**SALT AND GILA RIVERS  
TRES RIOS NORTH LEVEE**

**SUMMARY REPORT  
CONTRACT FCD 2010C027  
WORK ASSIGNMENT #2**

**Flood Control District of Maricopa County**

**WEST Consultants, Inc.**  
8950 South 52<sup>nd</sup> Street, Suite 210  
Tempe, Arizona 85284

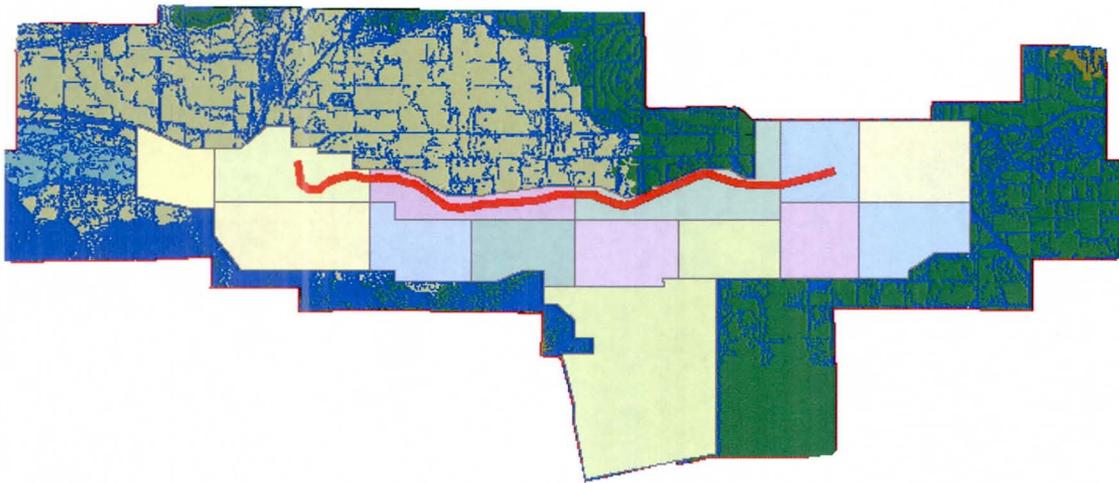
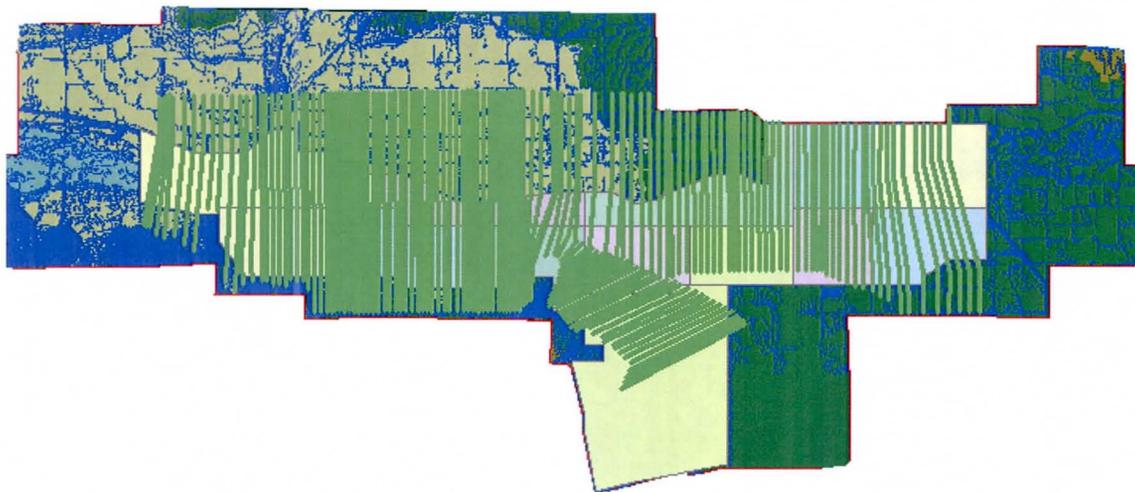
- The first figure shows the differentiation between the USACE topography data WEST received for the Tres Rios PED study and the topography that WEST appended to the USACE topography data in order to contain the 100-year flow in the model cross sections. The pastel polygons are the boundaries of the individual USACE topography datasets WEST received for PED, and the extents of all of these polygons are the total extent of this dataset. The remaining area of the TIN shown (with green and tan elevation contour colors and blue breaklines) would have been developed using supplementary data provided from a modeling study completed previously by WEST. In addition, the thick red line shown in this figure is the proposed levee alignment that WEST received from USACE during the PED modeling study. As can be seen in this figure, the levee alignment is contained entirely within the extents of the USACE topography, and does not cross into the topography appended by WEST.

- The second figure shows the same topography differentiation as the first figure, but the cross sections from the PED modeling study are shown on top of the polygons and TIN in order to show how much of those cross sections were taken from USACE topography data and how much were taken from the topography data that WEST appended. As can be seen from this figure, the area to the north of the levee in the right overbank was the largest area included in the PED model from the appended data.

Figure A1-11. Tres Rios Interior Drainage: Runoff Volume: 2-In, 24-Hour Storm (5-year Annual Event, 1% Annual Chance, Jan - Mar Event).

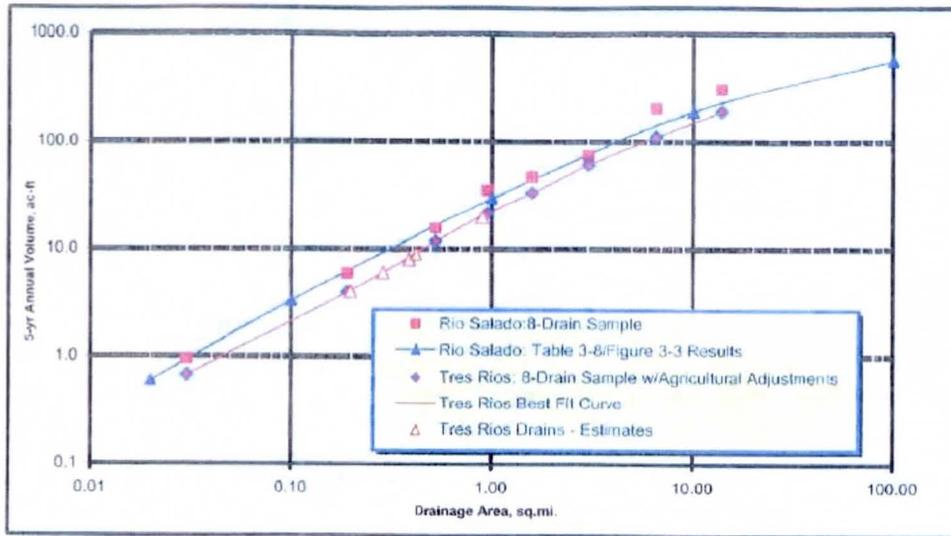
**WEST Note:** From the Figure below (Fig A1-11 in the DDR), the depth of precipitation used is 2.0 inches. Chuck: a point of clarity would be nice if the LACOE explained that the interior drainage did not have an existing 100-year floodplain as a result of local drainage – this to stop any possible future questions about the return interval used for the interior drainage design. Is this stated anywhere in the DDR? Also, they should point out any design standards they used relative to location (I don’t think they used a locally approved method), if this is what they did – how should we have them address this?

**Comment #5:** The catch basin interior drainage features were sized based on the 5-year, 24-hour precipitation depth of 2.0 inches. Paragraph 17 of the “Interior Runoff: Excess Precipitation” section of the interior drainage sub-appendix A1 of Appendix B [pages 353 and 354 of 568 in the DDR, pages 1-24 and 1-25 of the appendix] states that “The catch basin geometry was established to enable storage of the entire 5-year, 24-hour interior-runoff volume, and result in free drainage after 24-hours.”

Figure A1-10. Tres Rios Interior Drainage: 100-Year Peak Discharge versus Drainage Area, 8-Drain Urban Sample, Adjusted to Reflect Agricultural Drainage Areas.

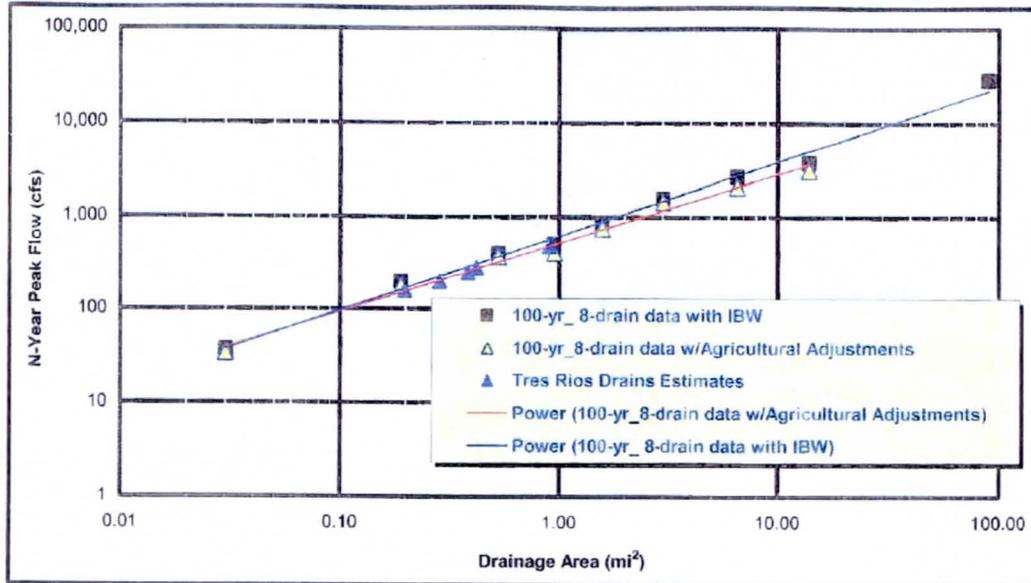
Chuck: Does the above mentioned Figure A1-10 show the sub-basin boundaries? If not it would be best for the LACOE to provide one. Please make a comment.

**Comment 4-2:** Brief discussions should be presented of (i) the fundamentals of the “8-drain sample” method for determining peak flows and volumes for the Rio Salado interior drainage area and (ii) the modification of this method for greater agricultural land use in the Tres Rios interior drainage area compared to the Rio Salado interior drainage area.

**Comment 4-3:** A brief discussion of the modification of the regression curves should be included as well. Were these regression curves generated from the output of the “8-drain sample” method?
